## **AMENDMENTS TO THE DRAWINGS**

## **AMENDMENTS TO THE DRAWINGS**

FIGURE 8

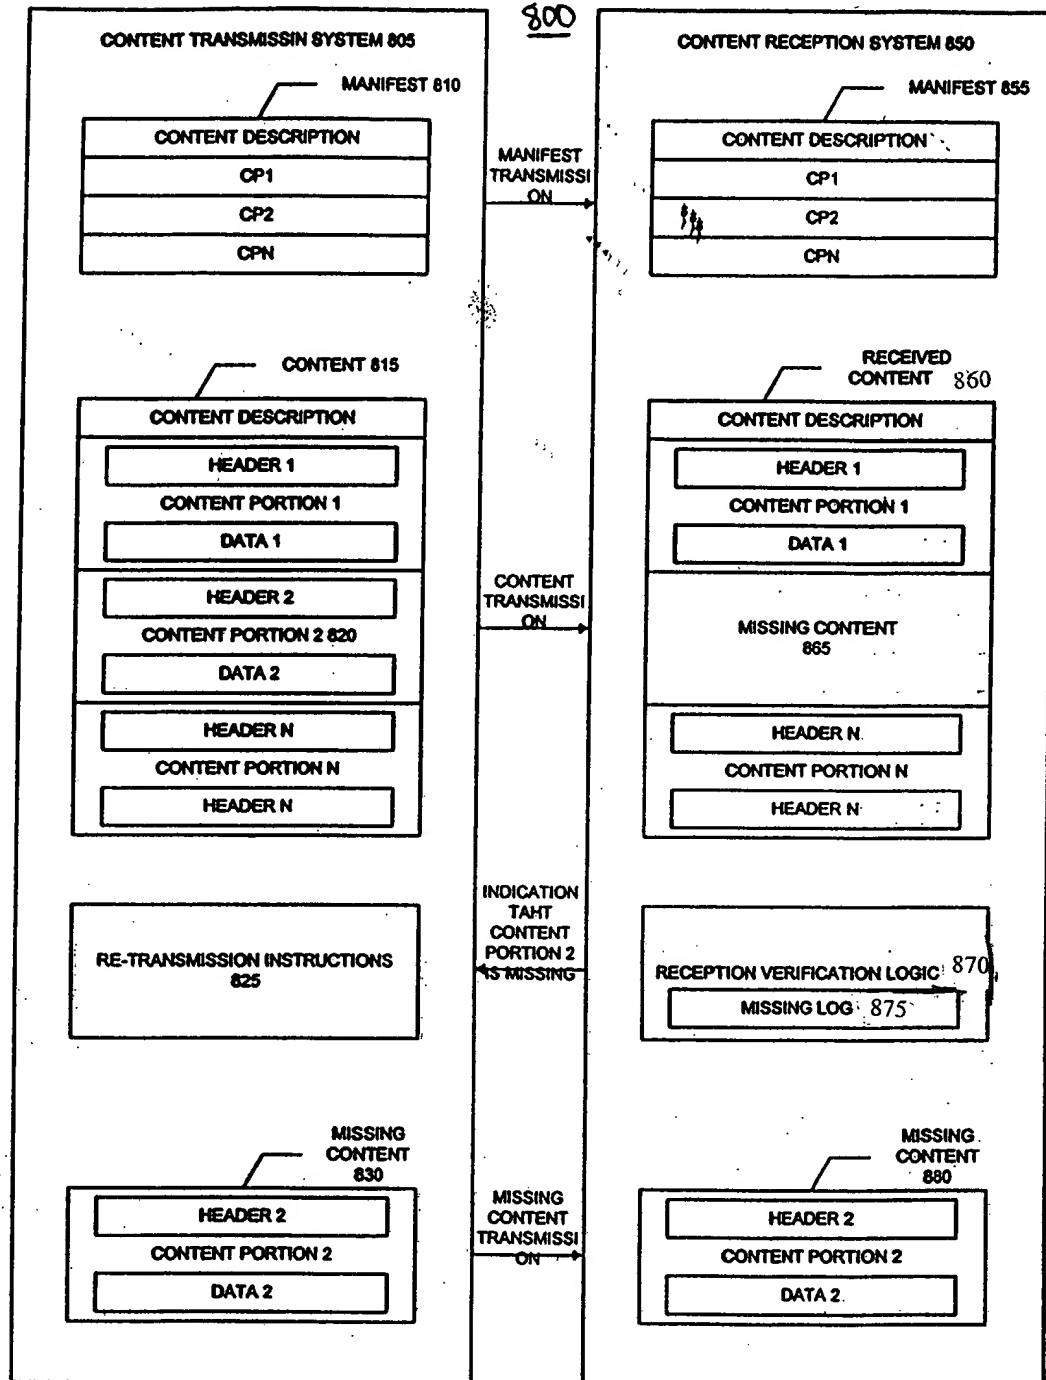
The attached sheets of drawings include changes to Figure 8. These sheets replace the original Figures. Figure 8 has been amended as follows: (1) original “received content 815” has been re-labeled as “received content 860; (2) “reception verification logic 970” has been re-labeled as “reception verification logic 870”; and (3) “missing log 975” has been re-labeled as “missing log 875”. These amendments are supported by paragraph [0075] of the specification. No new matter has been added.

The attached sheets of drawings include changes to Figure 8. These sheets replace the original Figures 8. Figure 8, second column, has been amended as follows:

“RECEIVED CONTENT 815” should be replaced with “RECEIVED CONTENT 860”; and

“RECEPTION VERIFICATION LOGIC 970” should be replaced with “RECEPTION VERIFICATION LOGIC 870”; and

“MISSING LOG 975” should be replaced with “MISSING LOG 875”.
